NORTHGATE TOWN SQUARE LANDSCAPE REVISIONS

PROJECT: NORTHGATE TOWN SQUARE
 ADDRESS: 1000 NORTHGATE DRIVE, SAN RAFAEL, CA 94903
 SUBJECT: LANDSCAPE REVISIONS
 DATE: JUNE 4, 2024

Please find below revisions per last issuance dated July 21, 2023.

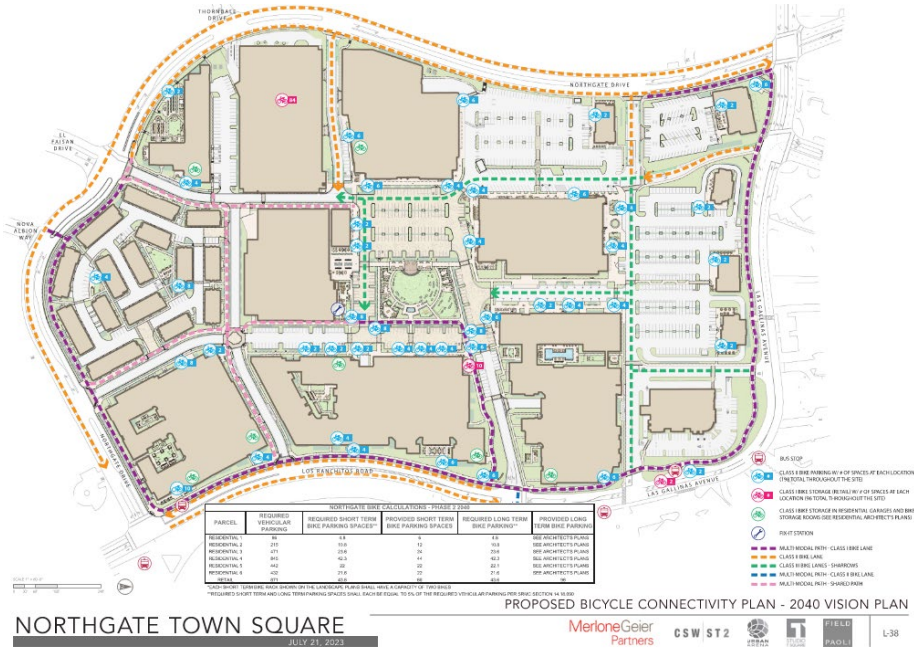
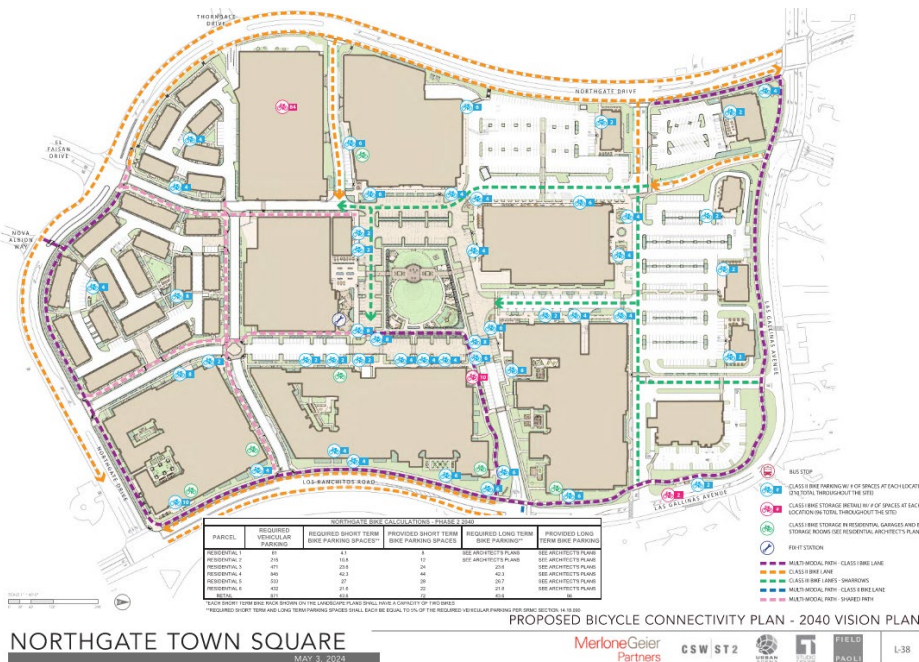
L-38/39 Proposed Bicycle Connectivity Plan and Pedestrian Connectivity plans. Short term bike parking has been adjusted at Residential 1, Residential 5, and the bike trail stops. Bike Parking at Residential 5 was increased by 6 stalls to meet the required number of stalls. The Pedestrian Circulation Plan has been adjusted to reflect site plan changes.

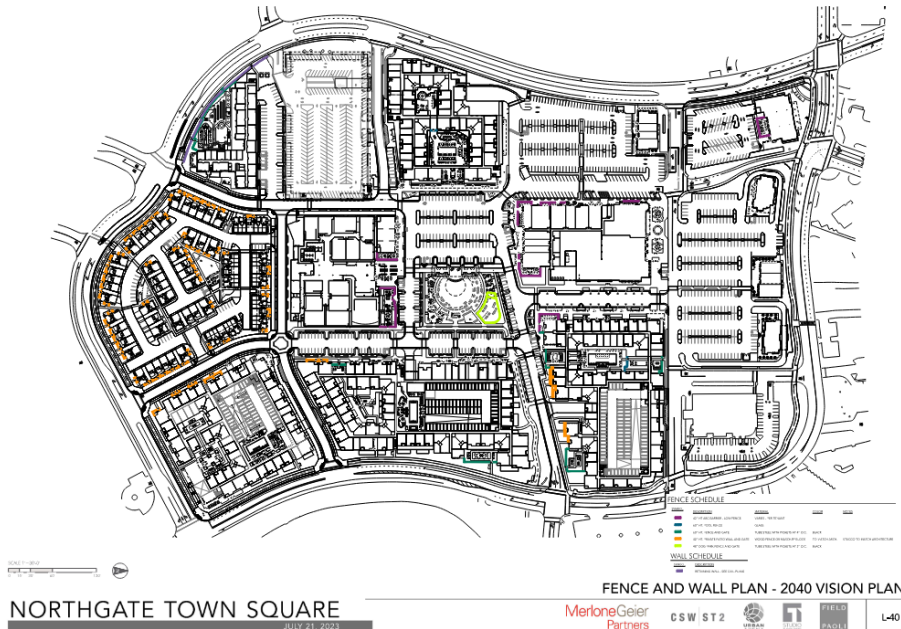
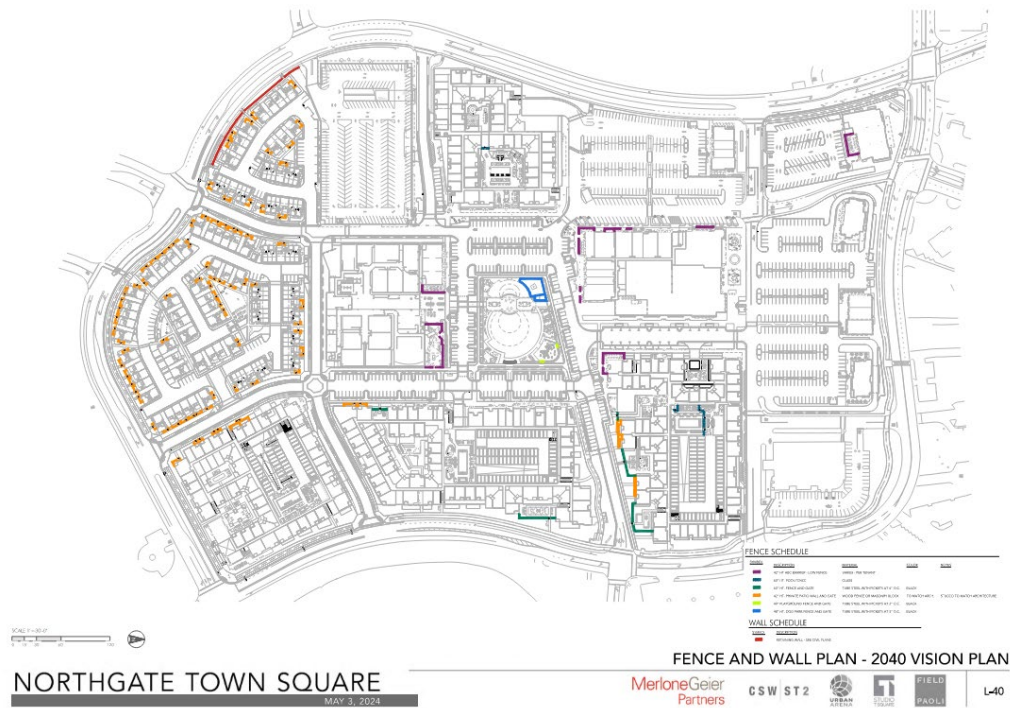
L-40 The Fence and Wall Plan has been updated to reflect site plan changes at Residential 1, the Town Square, and Residential 5.

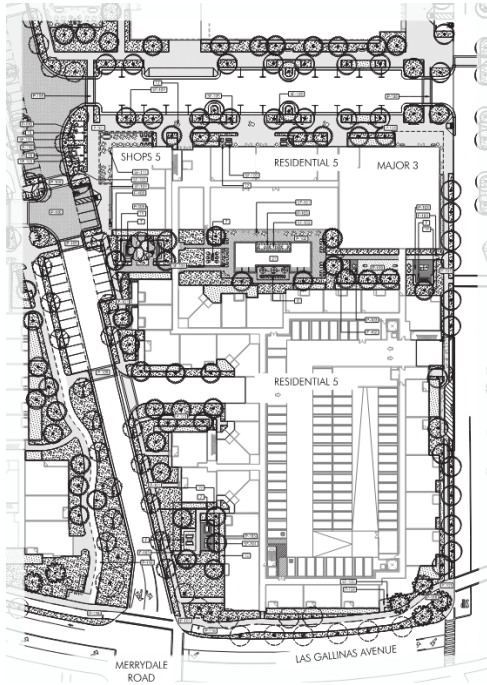
- L-42 Schedule and notes- Planting Schedule numbers, plant quantity estimates, and schedules have been updated per site plan changes.
- L-52 The Residential 5 Enlargement was adjusted to include adjustments to ground level patio and loading for major 4.

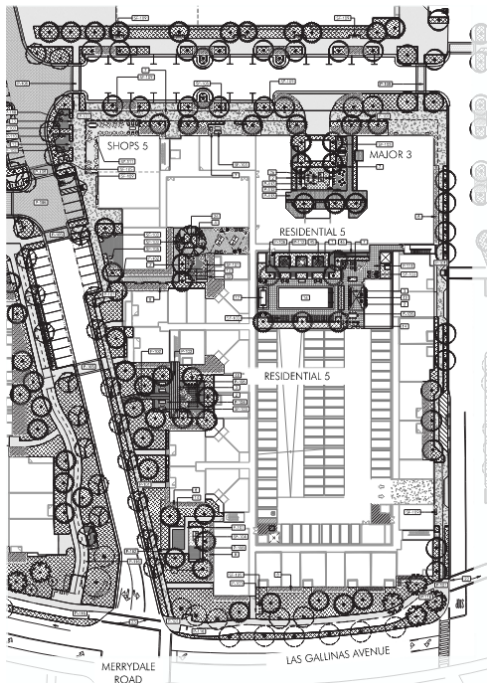
L-54 The Residential 5 Detailed Enlargement Plan has been adjusted to include all the changes to the Residential 5 layout.

SECTION 15

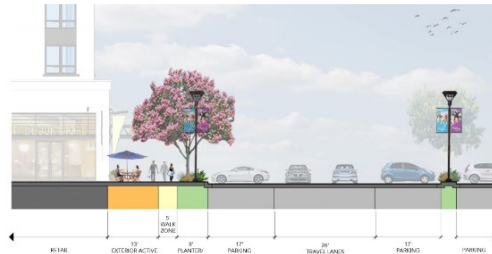
L-58 Section 15 and 16 have been updated with updated Residential facades.

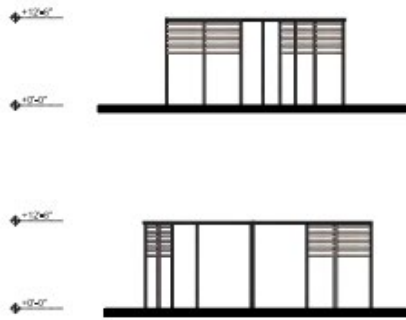
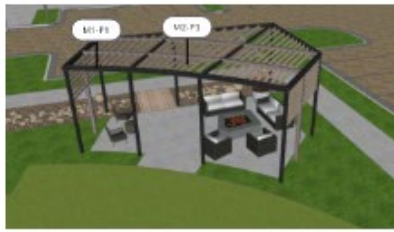
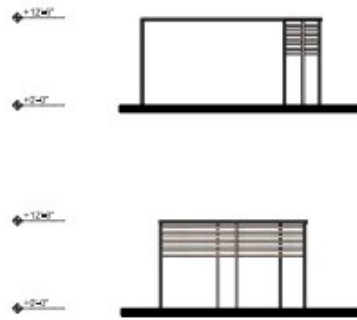
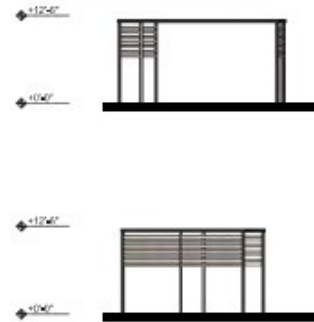
L-61 Town Square Overheads have been updated to match the current site plan.
